## Technical Service Information Bulletin

#### 2.0 Hydraulic Hose Clamping

**Bulletin Name:** FDM-TSIB-043

**Units Affected:** 2.0 Front Discharge Mixers

Figure 1

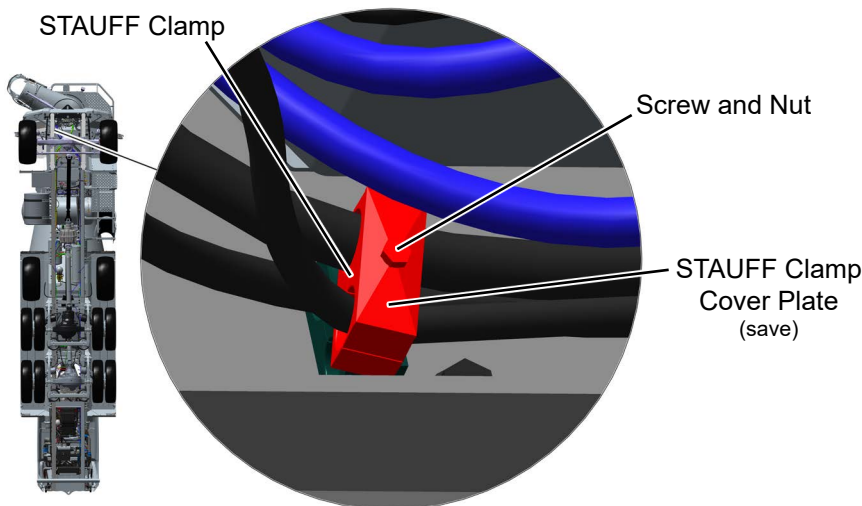
3. Locate STAUFF clamp on inside front of right-hand frame rail. See Figure 1.
4. Loosen and remove screw and nut securing STAUFF clamp to frame rail. See Figure 1. Locknut and screw will not be reused.

Figure 2

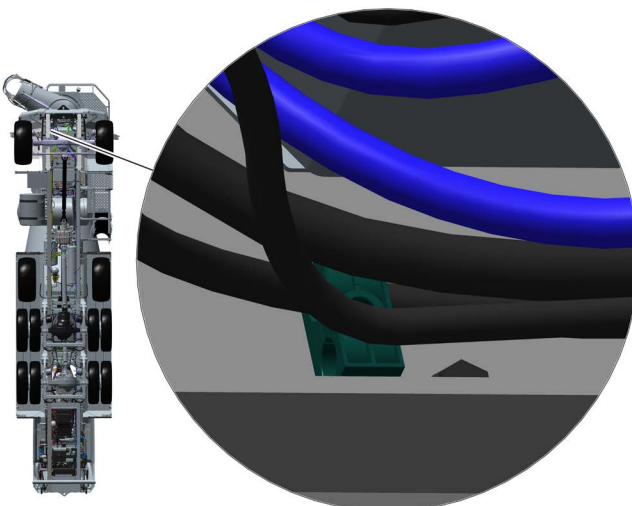
5. Remove outer STAUFF clamp and clamp cover plate. See Figure 2. Save cover plate for reinstallation, STAUFF clamp removed will not be reused.

*Figure 3*

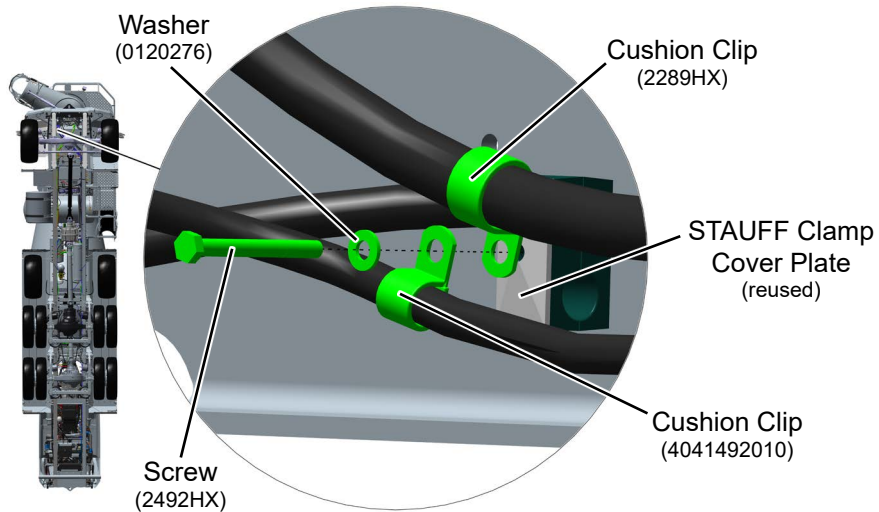
7. Install cover plate removed in Step 5 on remaining STAUFF clamp. See Figure 3. The cover plate will be slightly oversized when reinstalled.
8. Install 1.13 inch cushion clip (2289HX) on upper hydraulic hose #3126. See Figure 3 for clip orientation.
9. Install 0.69 inch cushion clip (4041492010) on lower hydraulic hose #3043. See Figure 3 for clip orientation.
10. Install flat washer (0120276) on 3.0 inch screw (2492HX).
11. Install 3.0 inch screw with flat washer through cushion clips, STAUFF clamp, and frame rail. See Figure 3 for installation order.
12. Install lock nut (1333510) on screw installed in Step 11. Hand tighten screw and nut, do not final tighten.

*Figure 4*

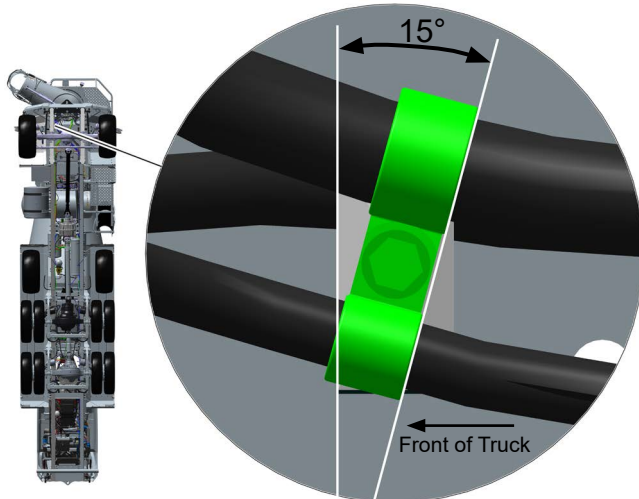
13. Position cushion clips as shown in Figure 4. Make sure upper hose #3126 does not contact bottom of cab. Make sure lower hose #3043 does not contact right-hand steer gear. Adjust clip orientations as necessary.

14. Final tighten mounting hardware to 9 ft. lbs.

Figure 5

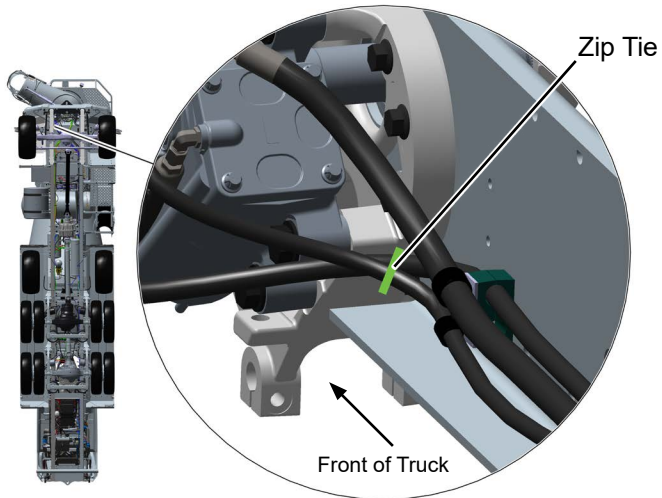
15. Add zip tie to hoses #3043 and #3104 as required to keep hydraulic hoses from contacting steering gear. See Figure 5 for zip tie location.

Figure 6

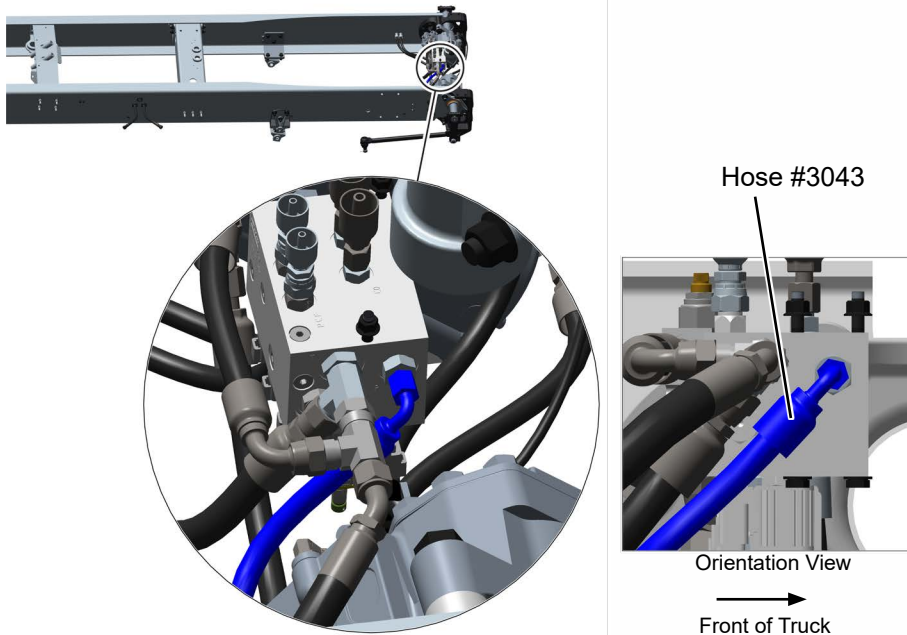
16. Make sure hose #3043 is correctly orientated at the chute manifold. See Figure 6.

Figure 7

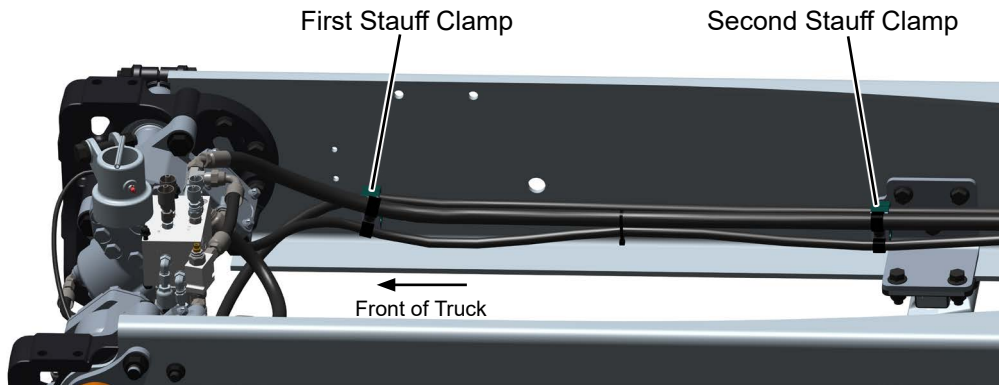
17. If changing out the second STAUFF clamp a 3.25 inch screw is required. Perform Steps 3 - 12 and Step 14 to change out the second STAUFF clamp. Orientation of the second clip stack is vertical, see Figure 7.
